FC9104
/A
/B
/C

Philips Domestic Appliances and Personal Care

Service Manual

To recognize the switches:

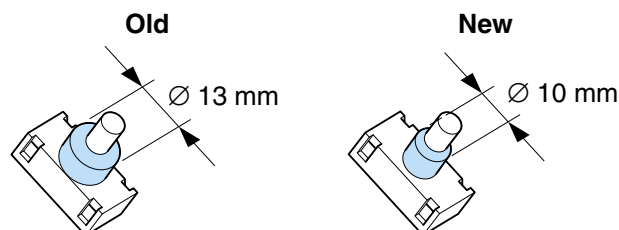
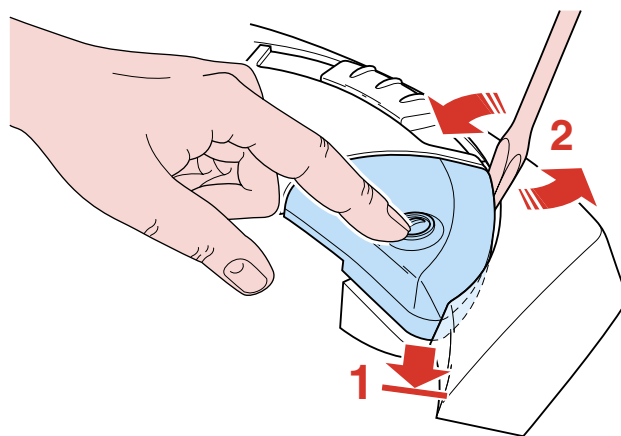
- Due to introduction of a **new switch** (item 11) 0320 onwards, which is not interchangeable with the old switch soldered on the PCB (item 12).
- The switch lever assy (item 11a) is also modified.

New spares are:

11	Switch soldered version	- 4322 006 50600
11a	Switch lever assy	- 4322 009 08980
parts of 15	Switch and Cord winder knob	- 4322 009 09000
